Service Letter SL 29 R6	DO - No. EASA.21J.020
--	------------------------------------	--------------------------

Additional Application of Carbon Fiber Plies in Blade Tip Area

Affected Propellers: MTV-15-B/210-58 and MTV-15-B/205-58 on Husky A1-()
MTV-15-B/203-58 on ACA Scout
MTV-15-C/200-50p / MTV-20-C/200-50p and MTV-15-()/183-50
MTV-12-()/()180-57

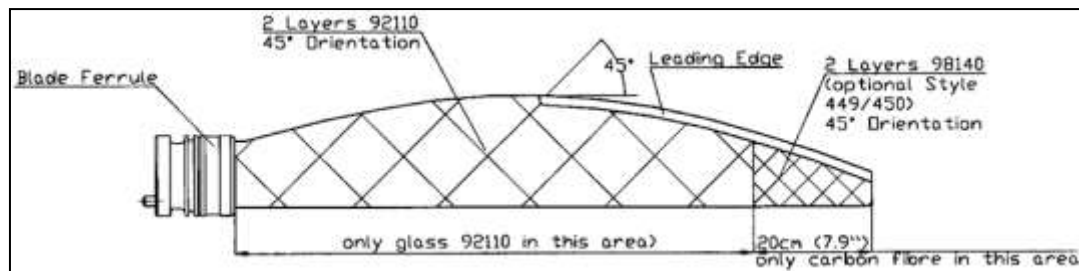
Reason: To improve the surface protection of the natural MT-Propeller composite blades and stainless steel / nickel protection erosion sheath on the above mentioned propeller models additionally to the 2 layers of fiber glass 2 layers carbon fiber must be applied (on the outer blade area only!).

2 layers of fiberglass CM 5 are applied on the blade with $\pm 45^\circ$ orientation up to 20 cm / 7.9 in from the blade tip.

2 layers of carbon fiber CM 27 (optional CM 28A, CM 28B or CM 28C) are applied on the blade with $\pm 45^\circ$ orientation in the last 20 cm / 7.9 in to the blade tip. NO glass fiber in this area!

Attention: The transition from glass fiber to carbon fiber must be smooth and the blade core must be fully covered by overlapping.

To ensure good overlapping the first layer of glass fiber must end 18 cm (7 in) from the blade tip and the second layer must end 22 cm (8.7 in) from blade tip. Respectively the first layer of carbon fiber starts 18 cm (7 in) from the blade tip and the second layer 22 cm (8.7 in) from the blade tip. By that an overlapping area of 4 cm (1.7 in) is assured.
